# **Teck Highland Valley Copper Partnership**

## **2018 Dam Safety Inspection Report**

### ***Highmont Tailings Storage Facility***

M02341B43.730

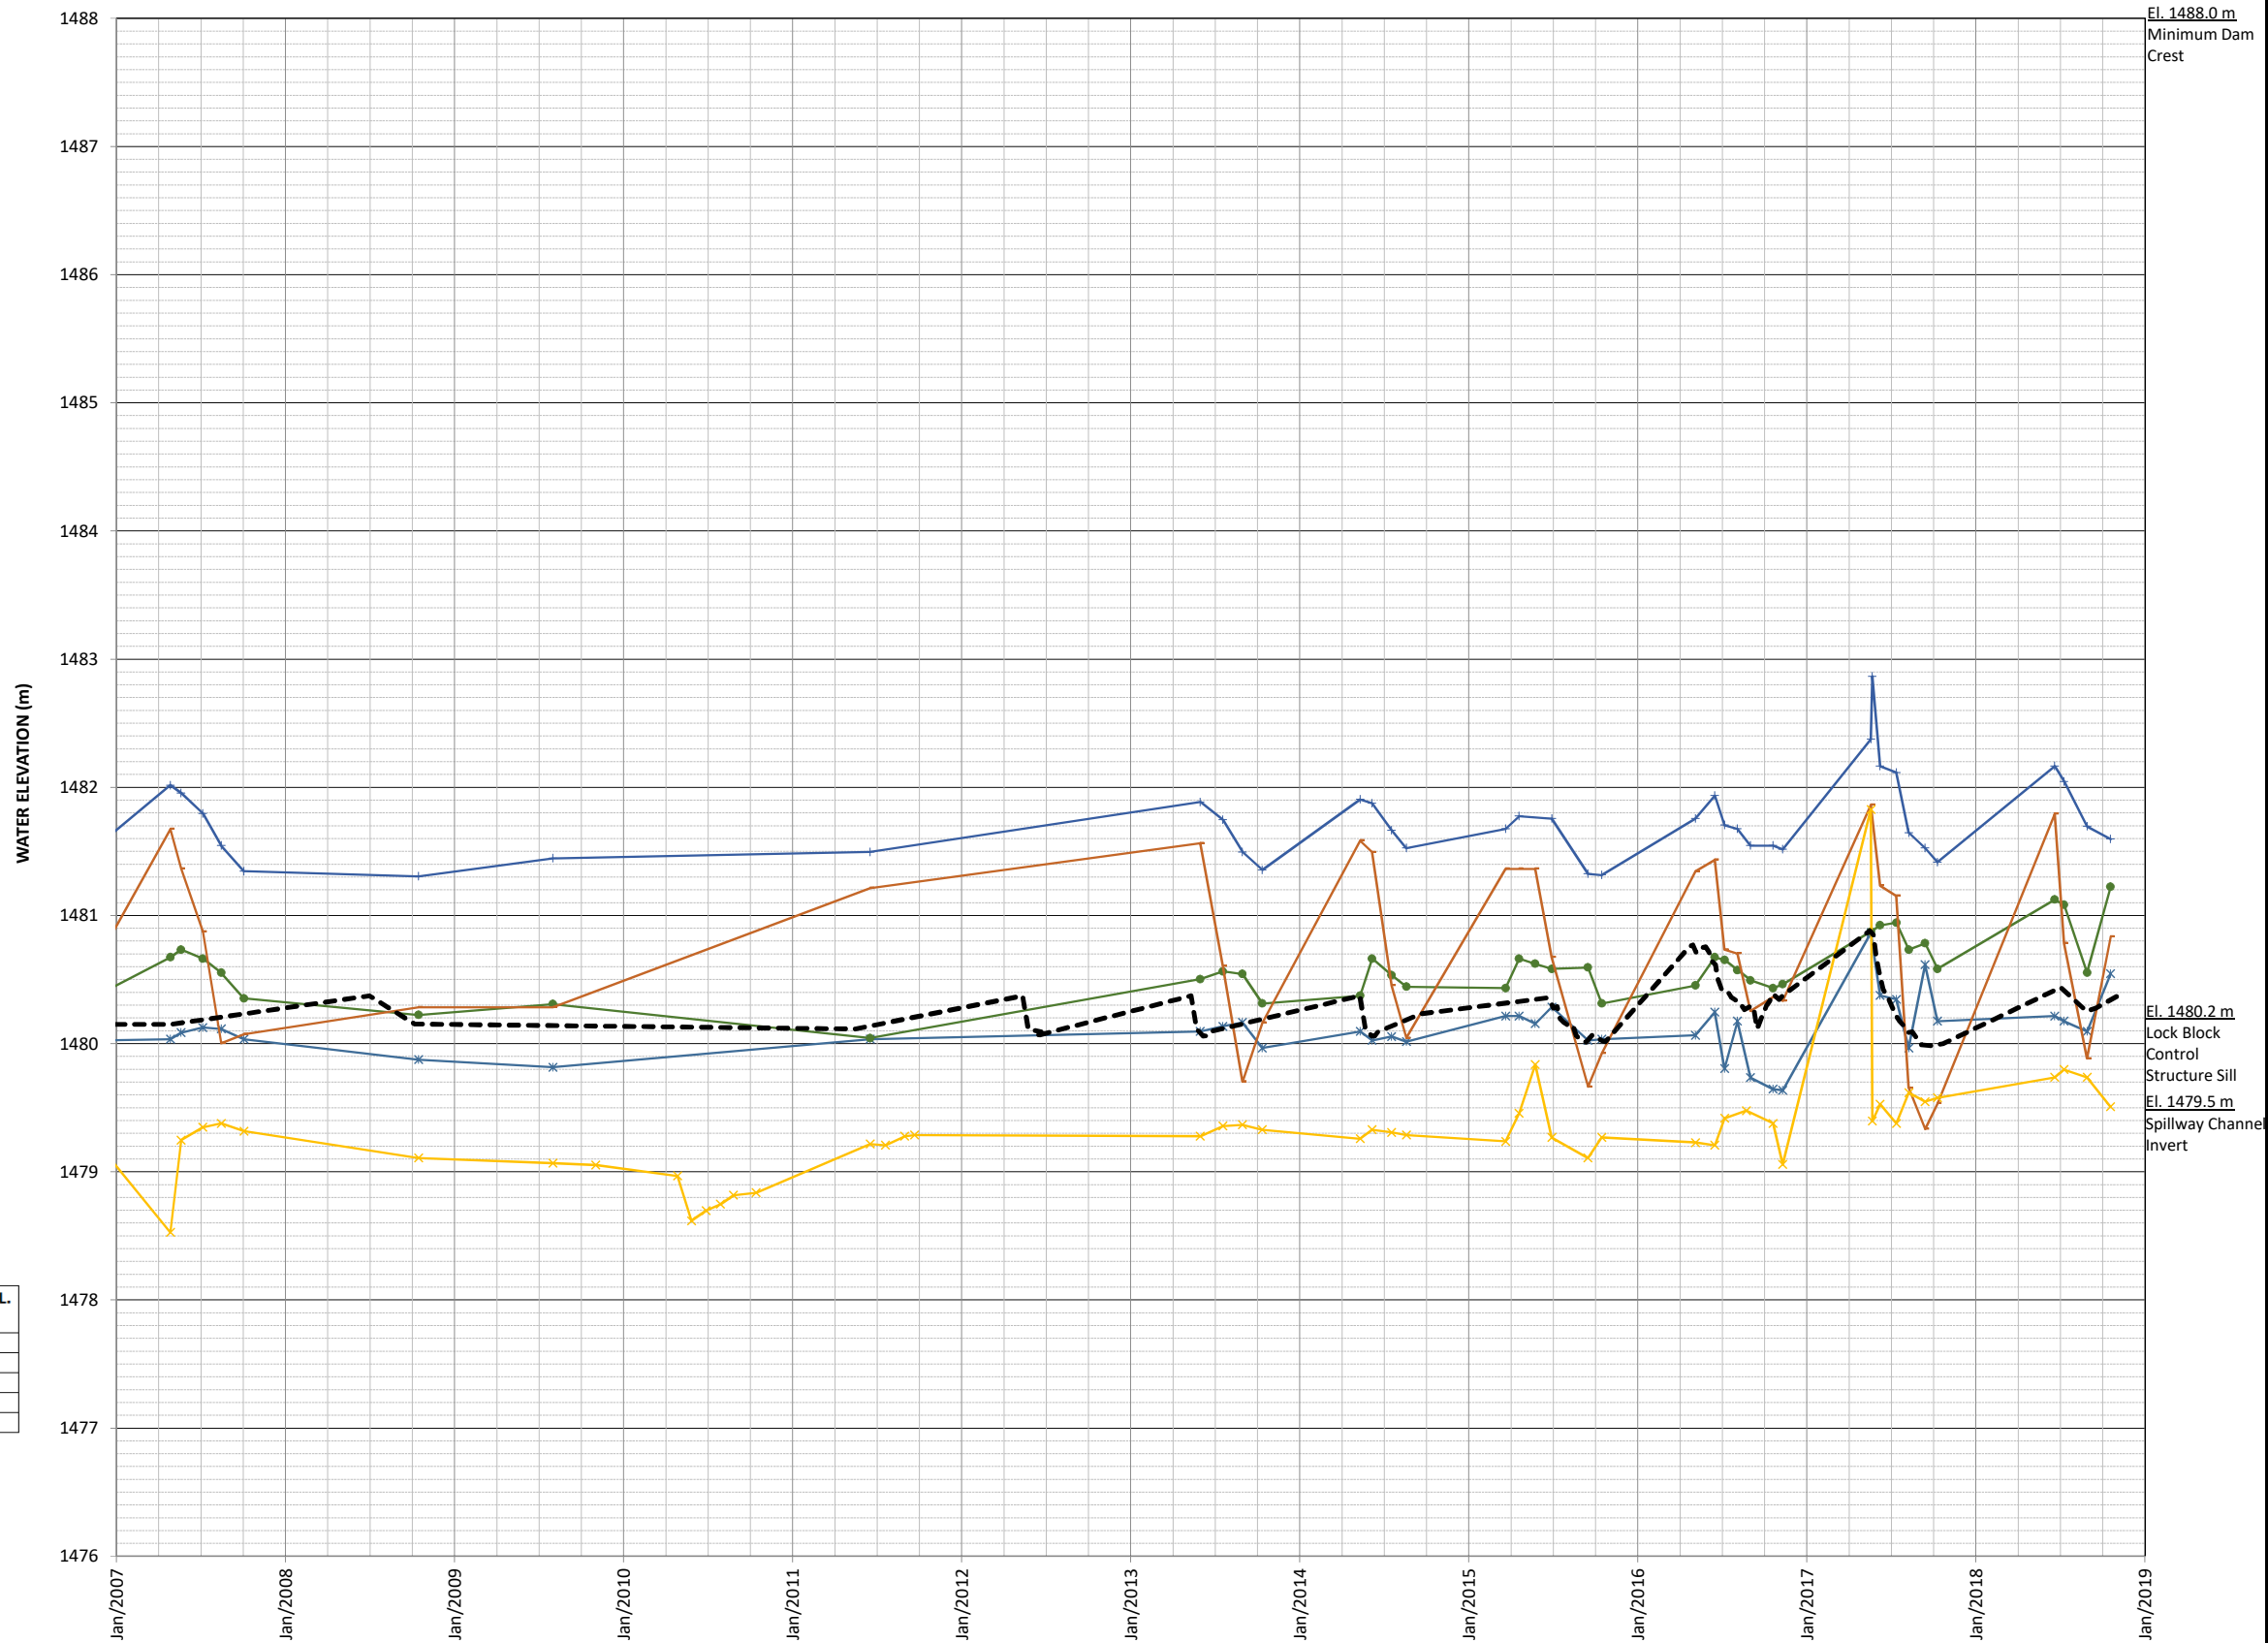
- PW-H and PW-L around the East Dam temporarily exceeded their threshold value in 2018 in response to freshet. In each case the readings dissipated to normal levels shortly after freshet passed. PW-L has shown an upward trend since 2017 (~1 m rise). PW-H and PW-L had their Notification Level thresholds updated in 2017 because a 2017 freshet temporary exceedance.

MONUMENT ID	2018 THRESHOLDS		
	HORIZONTAL DISPLACEMENT FROM ORIGINAL POSITION (mm)	INCREMENTAL SETTLEMENT BETWEEN READINGS (mm)	TOTAL SETTLEMENT (mm)
P2	80	20	50
P3			50
P4			75
P5			50
P6			75
P7			75

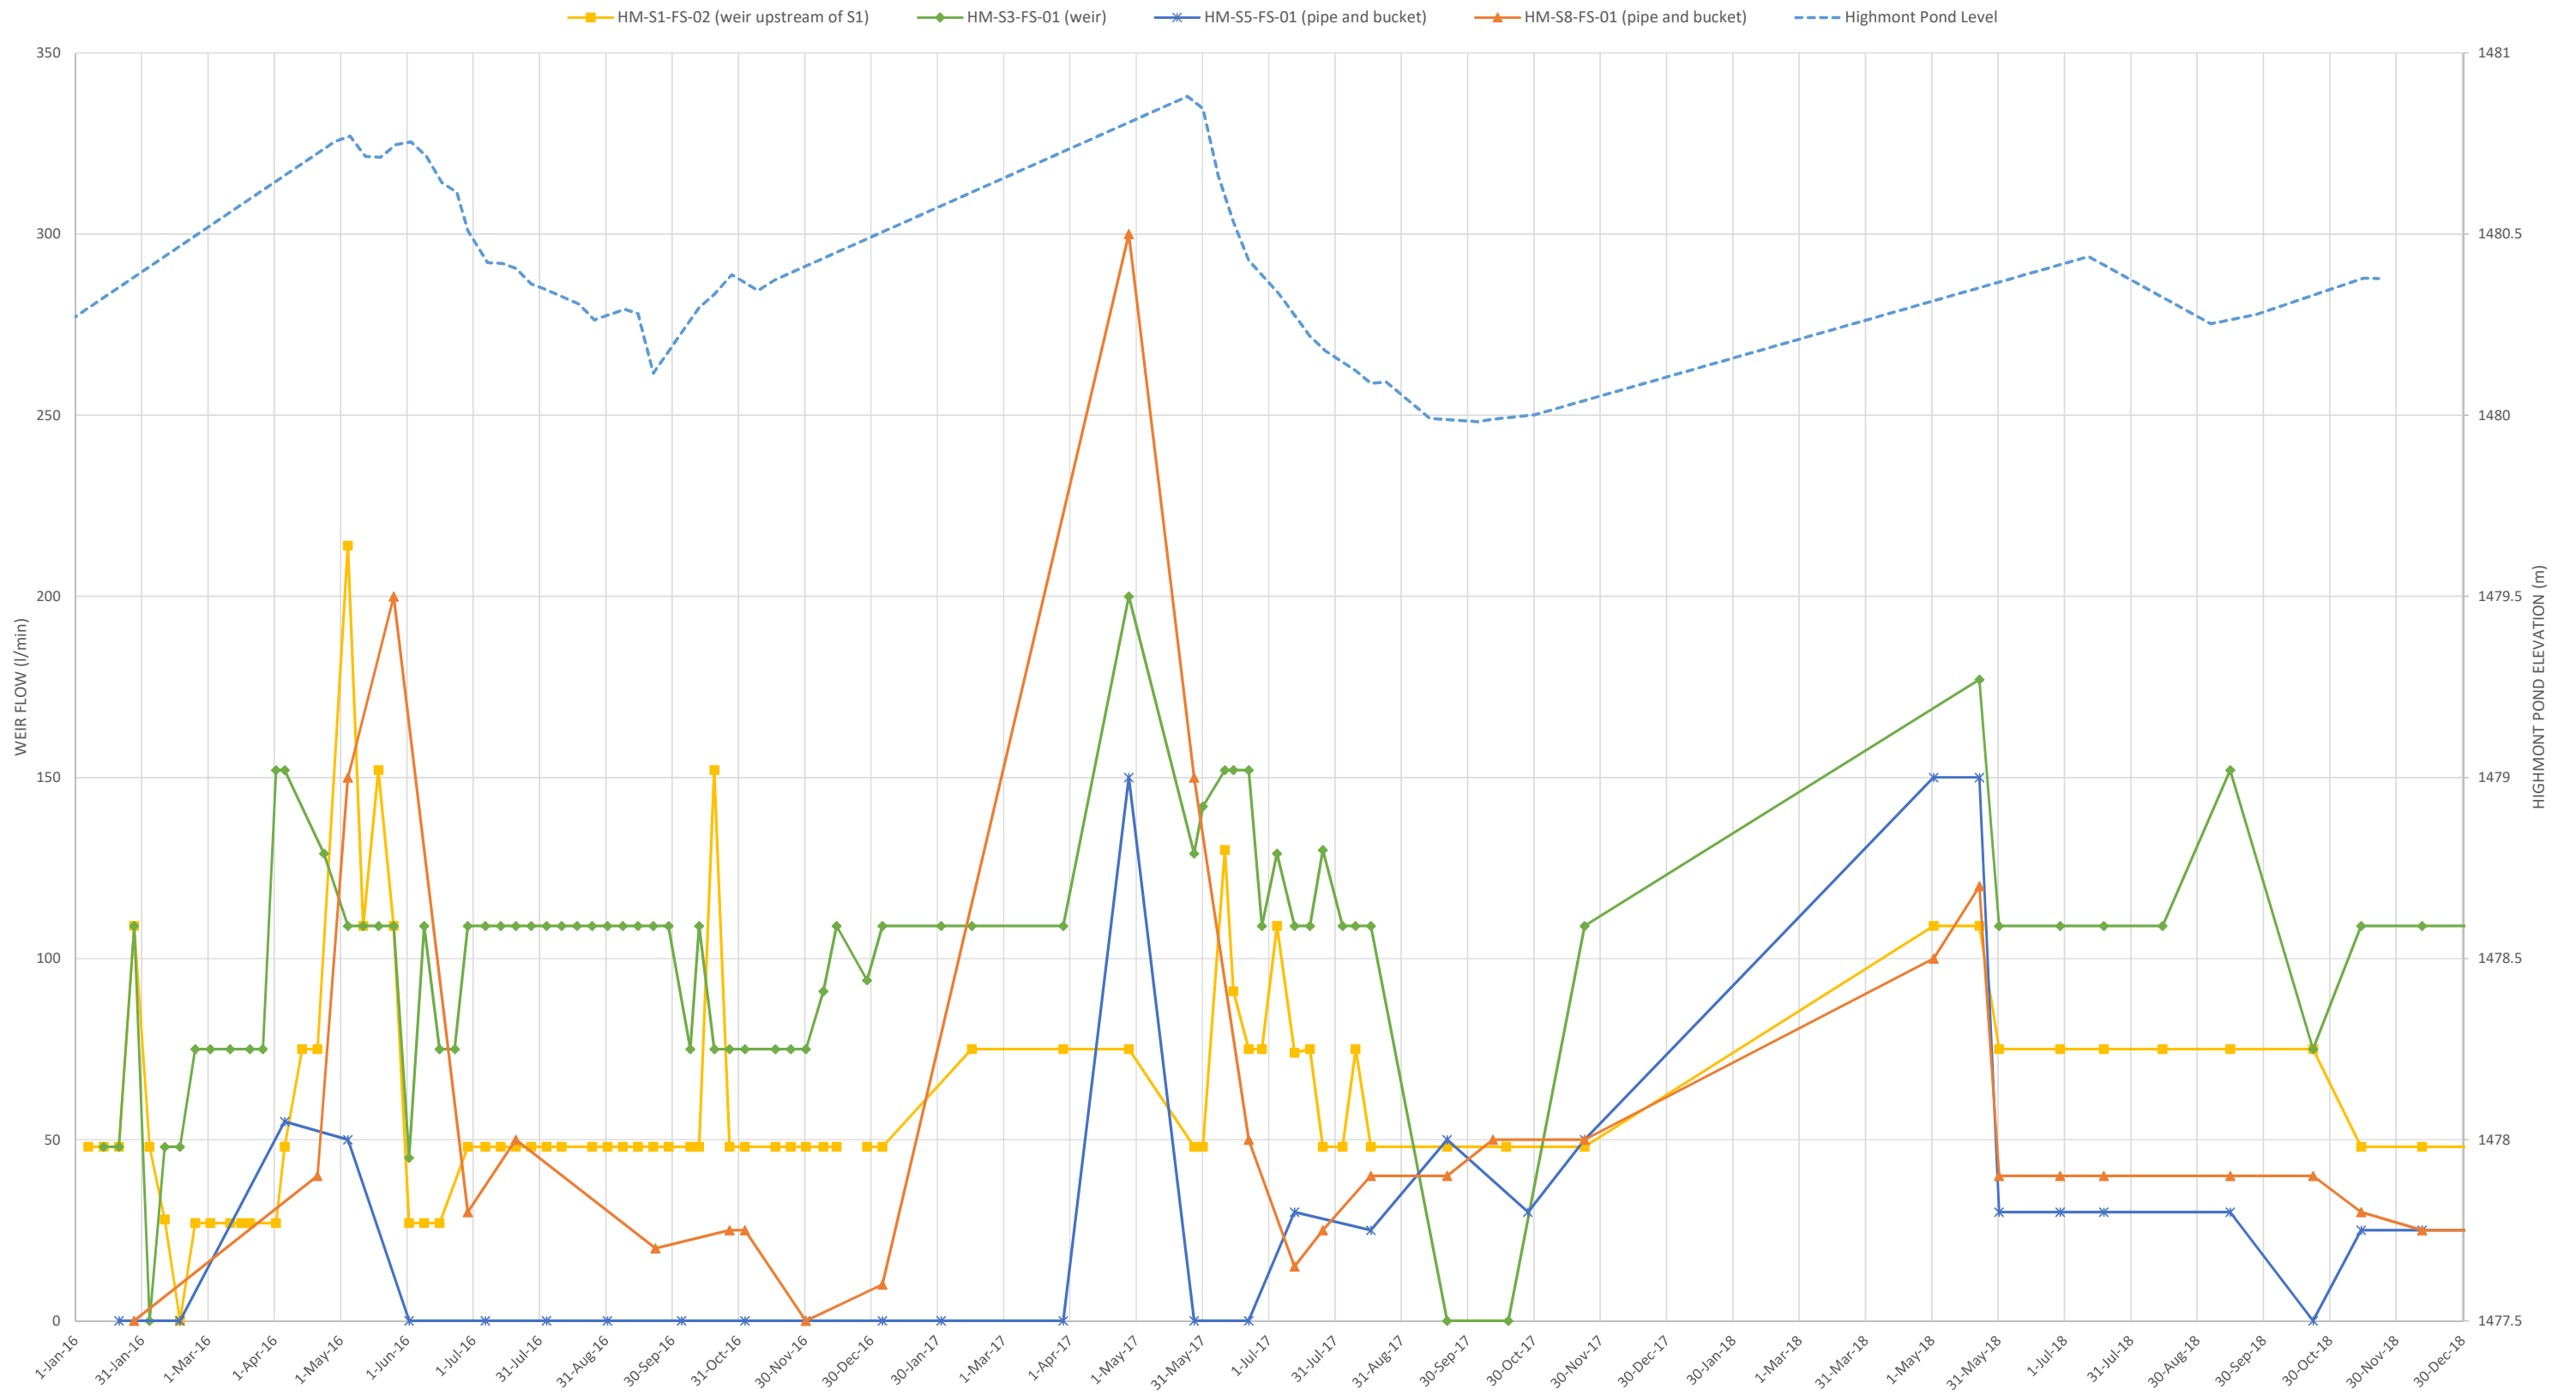
- P4 exceeded its horizontal movement threshold in 2018 (115 mm movement relative to 2007 original location; threshold set as 80 mm). The movement however was in the northeast direction perpendicular to the dam orientation, slightly in the upstream direction, which aligns with the variance observed at this location. No accompanying change in vertical settlement was observed. No significant indicators of distress in the dam observed in this area during site visit. Therefore, this is not considered a dam safety concern. KCB recommends reading P4 again in 2019 spring after snow clearing to confirm movements. 2018 survey of other monuments are consistent with previous surveys with no threshold exceedances.
